CERTIFICATE OF APPROPRIATENESS

Property: 801 Key Street, Lot 18, Block 221, East Norhill Subdivision. The property includes a historic 1,414 square foot, one-story wood frame single-family residence and historic detached garage situated on a 6,157 square foot (59.20' x 140.00') corner lot.

Proposal: Alteration – Construct an approximately 1,100 square foot two-story addition on top of, to the side of, and to the rear of a contributing structure.

Recommendation: Denial - does not satisfy criteria 1, 4, 8, 9

SOUTH ELEVATION – FRONT FACING KEY STREET
EXISTING

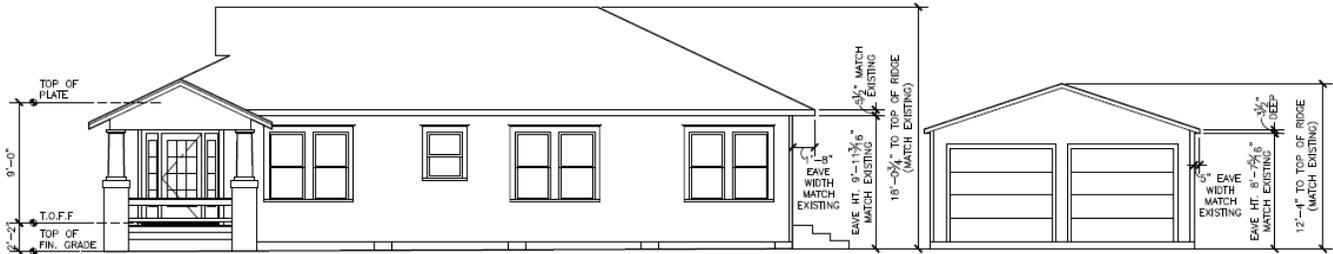
The encroachment of the proposed addition onto 50% of the original structure and expansion out to the side and rear, severely impacts the historic character of this corner structure and property. The second story addition will encroach 50% onto the existing structure, while the covered screened porch and side addition will be begin 18' back from the front wall.
- (2) The proposed activity must contribute to the continued availability of the property for a contemporary use;
- (3) The proposed activity must recognize the building, structure, object or site as a product of its own time and avoid alterations that seek to create an earlier or later appearance;
- (4) The proposed activity must preserve the distinguishing qualities or character of the building, structure, object or site and its environment;

The encroachment of a one- and two-story addition over the rear half, as well as out to the side and to the rear, heavily alters the distinguishing character (including windows, siding, shiplap, and roof framing) of the historic one-story residence and negatively impacts the structure visually. Both the first- and second-story portions of the addition should be moved farther towards the rear of the property in order to both minimize the visual impact and to preserve the distinguishing qualities of the building.

EAST SIDE ELEVATION FACING WATSON STREET

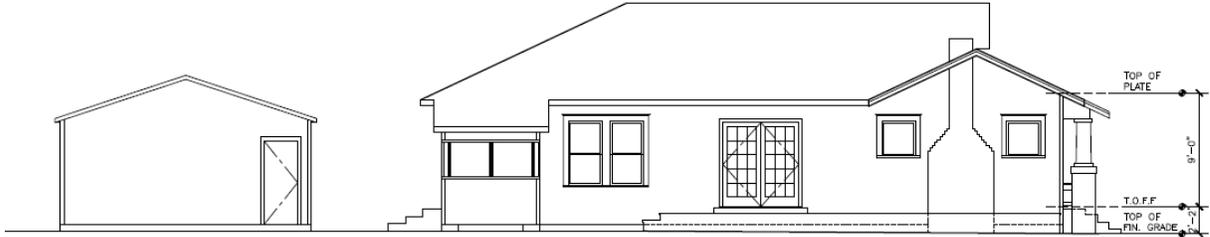
The proposed two-story addition as well as the alterations towards the rear of the structure removes a significant portion of historic material, including siding, windows, and roof framing. Several windows along the Watson Street elevation will be removed, the covered screened porch and west side addition will begin 18' from the front wall, necessitating the existing roof to be altered and wall material, shiplap, and siding to be removed. The second-story addition will begin 50% back from the front wall, destroying half of the existing roof structure and impairing the character of the one-story Bungalow.

DEMOLITION PLAN

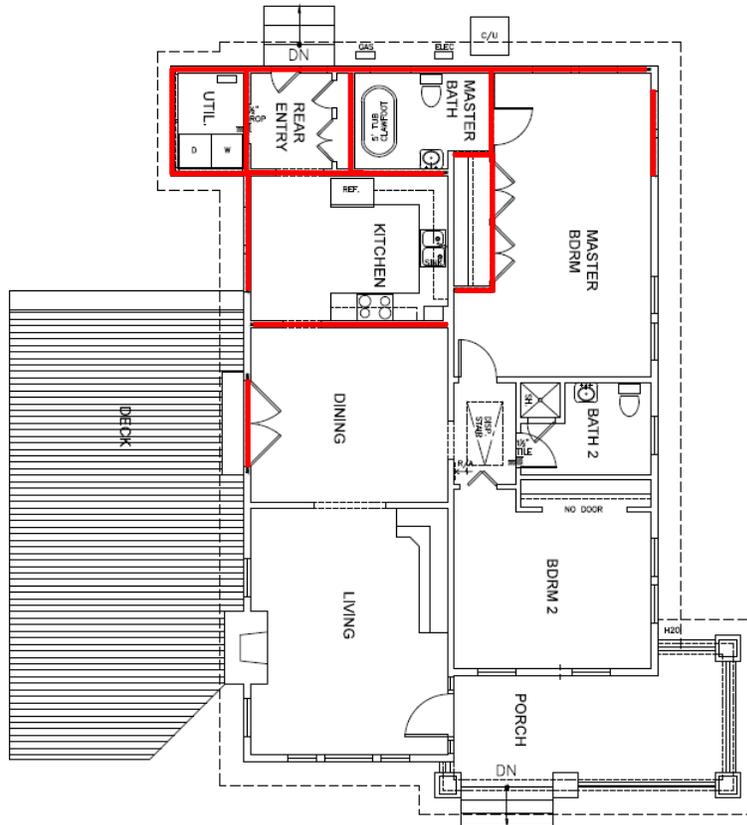
Constructing a second-story addition atop half of an existing one-story building while removing and altering large sections of the rear and sides (including windows, siding, shiplap, and roof framing) impairs the essential form and integrity of the existing historic structure. In order to minimize or eliminate the detrimental impacts to the historic form and integrity of the building, the proposed addition should begin farther towards the rear of the property and expand back, not over the existing structure.
